Exelon Nuclear
200 Exelon Way
Kennett Square, PA 19348

Limerick Generating Station, Unit 1
Facility Operating License No. NPF-39
NRC Docket No. 50-352

SUBJECT: License Amendment Request: AR A1443067
Safety Limit Minimum Critical Power Ratio (SLMCPR) Change

LICENSE AMENDMENT REQUEST: AR A1443067

Figure 2 - Cycle 11 Reference Core Loading Pattern

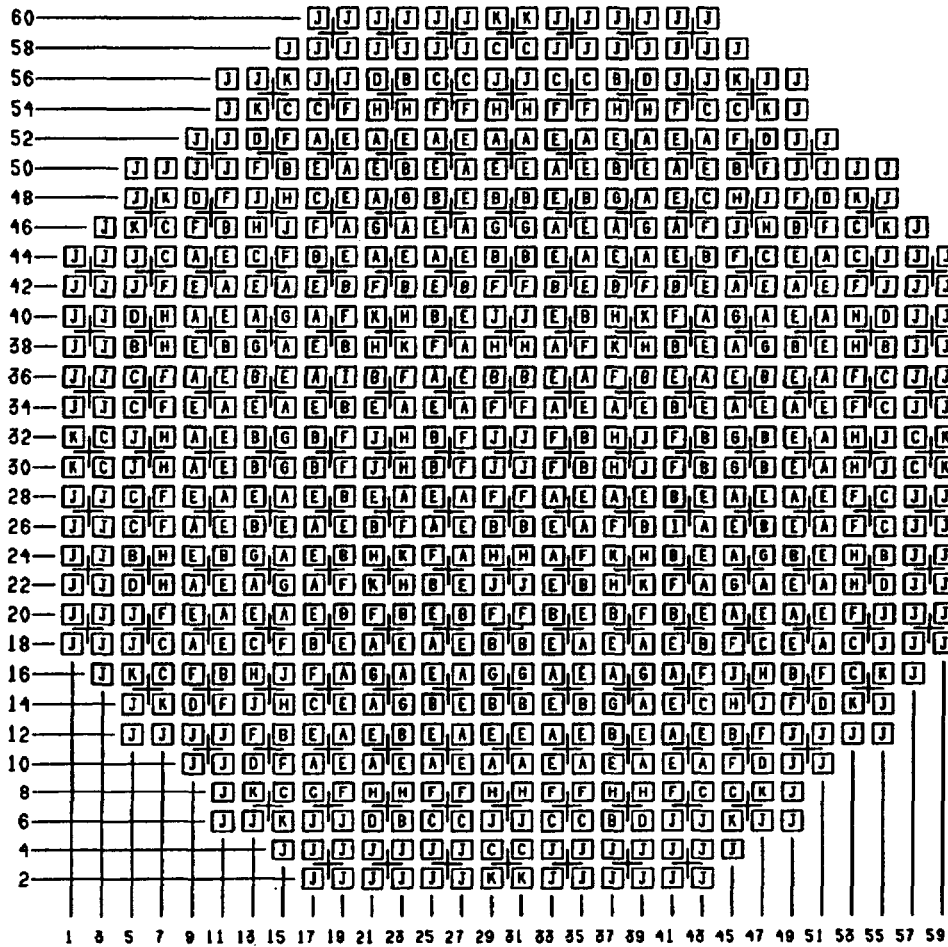
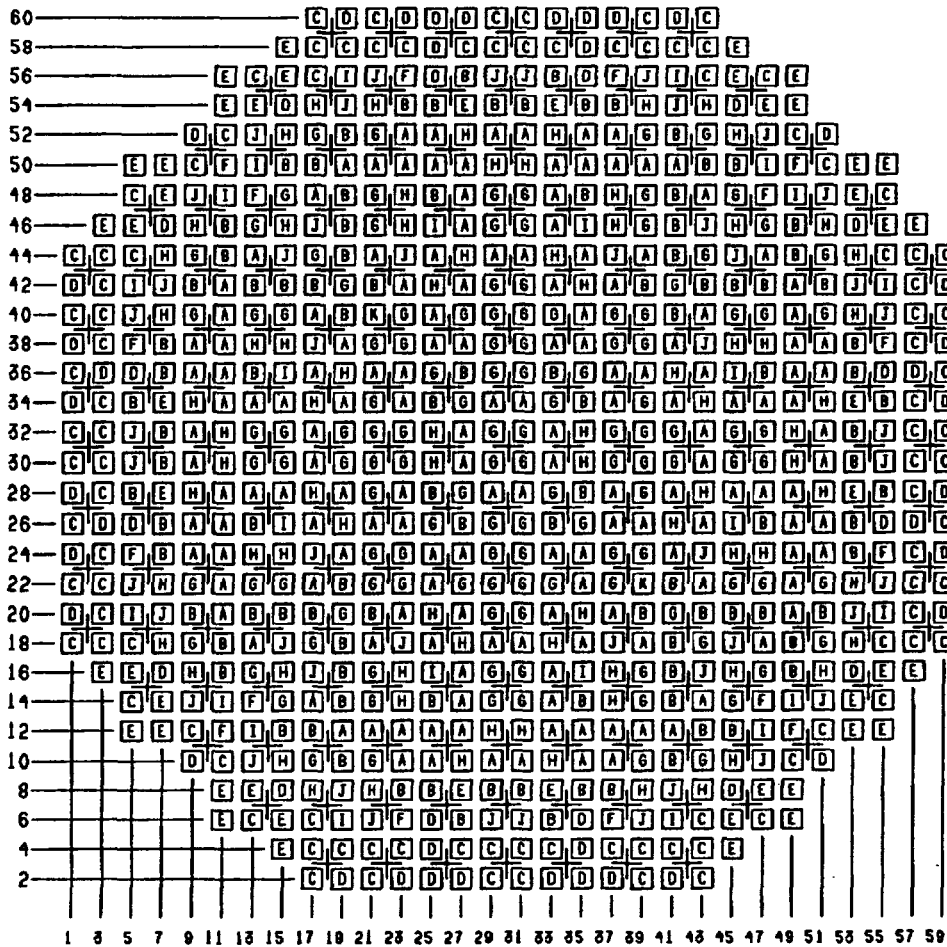
The core loading information for Limerick 1 Cycle 10 is provided in Figure 1. For comparison the core loading information for Limerick 1 Cycle 11 is provided in Figure 2. The impact of the fuel loading pattern differences on the calculated SLMCPR is correlated to the values of [[
